CP/BH/AC
13177
12 October 2016

**SECTION 96(1A) MODIFICATION APPLICATION
SICEEP, DARLING SQUARE, NORTH-WEST PLOT**

On behalf of Lend Lease (Haymarket) Pty Ltd (lendlease) we hereby submit an application pursuant to section 96(1A) of the *Environmental Planning and Assessment Act, 1979* (EP&A Act) to modify Development Consent SSD-6013 relating to the development of the North West Plot of Darling Square which is part of the Sydney International Convention, Exhibition and Entertainment Precinct (SICEEP) at Darling Harbour, Sydney.

Figure 2 – Extent of car parking screening and bevelled pattern example

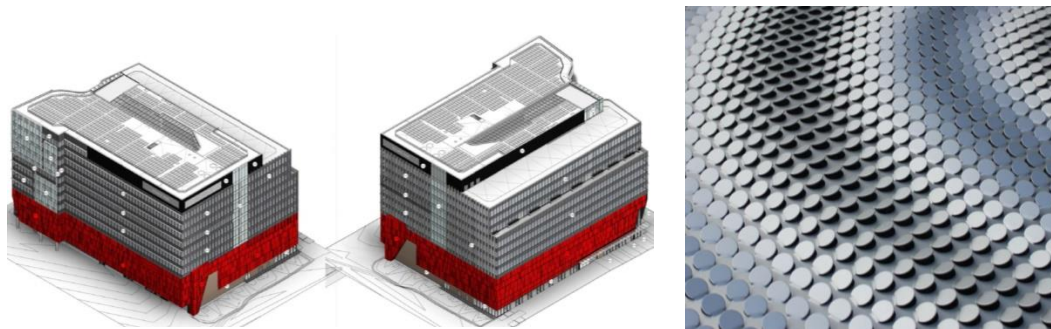
Ongoing design development has occurred on the façades of the approved building, in particular at the above ground car parking levels. An alternative metal cladding material is now proposed to screen the above ground car parking on levels 1 to 4 (refer to **Figure 2**). The screening will comprise an 'Ombrae' cladding system which is similar to an activated 'skin'.

This skin is developed using computer modelling, where a digital system creates three dimensional pixels and allows for an image to be translated onto an array of optical tiles. Each optical tile is a bevelled and cylindrical 'pixel' with an angled surface that reflects a particular amount of light (refer to **Figure 2**). The array of optical tiles sculpts the reflected light into an image. A sandstone aesthetic is proposed to be adopted for the North-West building car park screening.

Figure 4 – Minor building encroachments above the parameter plan envelope

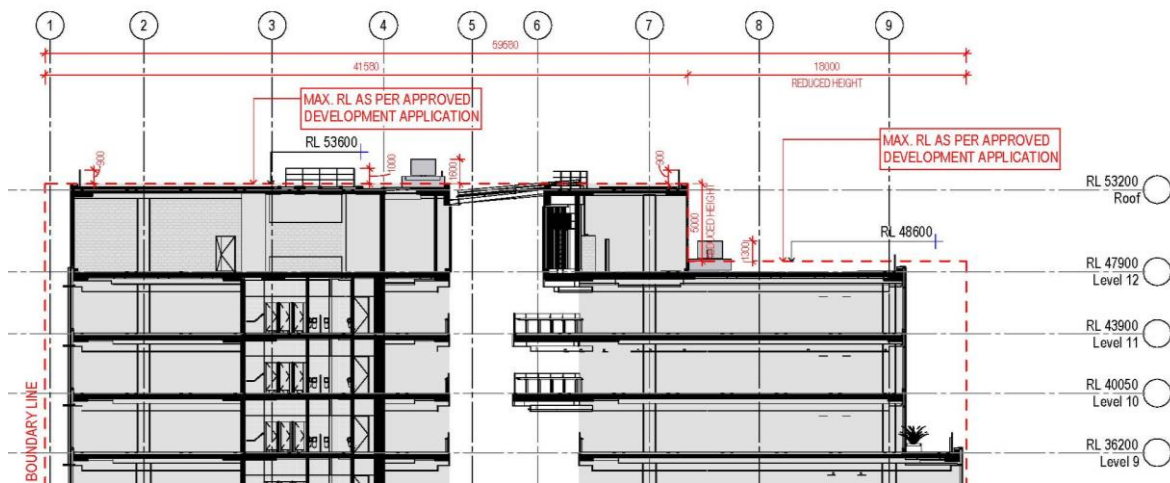
The intent of the wording in these conditions is to acknowledge that the detailed development applications may propose slight variations where finer grain details of buildings are tested and shown to require alternative solutions/outcomes. This is the case in the proposed modification, where it has been identified that a variation to the approved building envelope is required to allow for the BMUs and safety balustrades on the roof level.

The proposed encroachment of the parameter plan envelope is considerably minor in the scale of the building (refer to **Figure 4**). The proposed encroachments are directly the result of enhancing safety and ensuring necessary maintenance access. Both elements, being the BMUs and safety balustrade, serve an important role in maintaining the building throughout the life of the development.

The potential visual impacts of these elements has been minimised in the design and placement of each element. When not in use, the BMUs will be collapsed and will be parked in predetermined locations centrally to the roof. The BMU on Level 12 will be parked adjacent to the plantroom louvres and painted in a similar colour as the louvres (charcoal grey) to ensure it is recessed in the massing of the roof form. The BMU on Level 13 will be parked away from the building edge, centrally on the roof and painted in a silver colour that is consistent with the PV panels across the wider roof.

The proposed roof level balustrade is designed as a slim steel structure, setback in part from the roof line to not contribute any bulk or scale to the edge of the building envelope. These design moves also ensure that any potential shadow associated with the elements is contained on the roof of the building, or is minimal in extent to not cause any significant overshadowing impacts to the surrounding public domain.
